Access Compliance Report

Public Rights-of-Way

(Curb Ramps)

Intersection ID: 11965	Main Street: S_CEDAR_ST	Cross Street: GREENLEAF_AV	Location: W
ADA ID: 755CEF17D07E	Ramp Type: PerpDiag	Initial Pass/Fail: Fail	Overall Compliance: No
Severity Score: 22.5			
Codes/Mitigation Info/Possible Solution		Field Measurements/Component Compliance

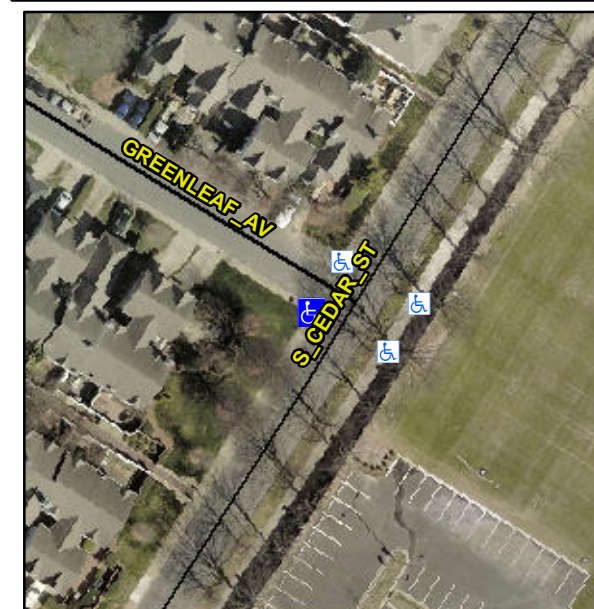
Not Found, R304.5.1, R304.2.2, R304.5.3

Compliance	Description	Data	Compliance	Description	Data
N/A	Ramp Length (in)	33.0	No	Ramp Slope (%)	9.1
No	Ramp Width (in)	40.0	No	Ramp XSlope (%)	4.5
N/A	Flare Type LT	N/A	N/A	Flare Type RT	N/A
N/A	Flare Slope LT (%)	N/A	N/A	Flare Slope RT (%)	N/A
N/A	Flare Traversable LT?	N/A	N/A	Flare Traversable RT?	N/A
N/A	Landing Length (in)	N/A	N/A	DWS Provided?	N/A
N/A	Landing Width (in)	N/A	N/A	DWS Contrast?	N/A
N/A	Landing Slope (%)	N/A	N/A	DWS Length (in)	N/A
N/A	Landing X Slope (%)	N/A	N/A	DWS Full Width?	N/A
N/A	Landing Curb? (Y/N)	N/A	N/A	DWS Offset (in)	N/A
N/A	Shared Landing?	N/A			
N/A	Gutter Ponding?	N/A	N/A	Gutter Slope (%)	N/A
N/A	Gutter Lip Ht (in)	N/A	N/A	Gutter X Slope (%)	N/A
N/A	Painted X Walk1?	No	N/A	Painted X Walk2?	No
	X Walk 1 Direction	To SE		X Walk 2 Direction	To NE
N/A	X Walk 1 Width (in)	N/A	N/A	X Walk 2 Width (in)	N/A
	X Walk 1 Slope (%)	5.9		X Walk 2 Slope (%)	2.0
	X Walk 1 X Slope (%)	1.2		X Walk 2 X Slope (%)	2.8

Remove & Replace Curb Ramp With Two New Directional Ramps or Equivalent.
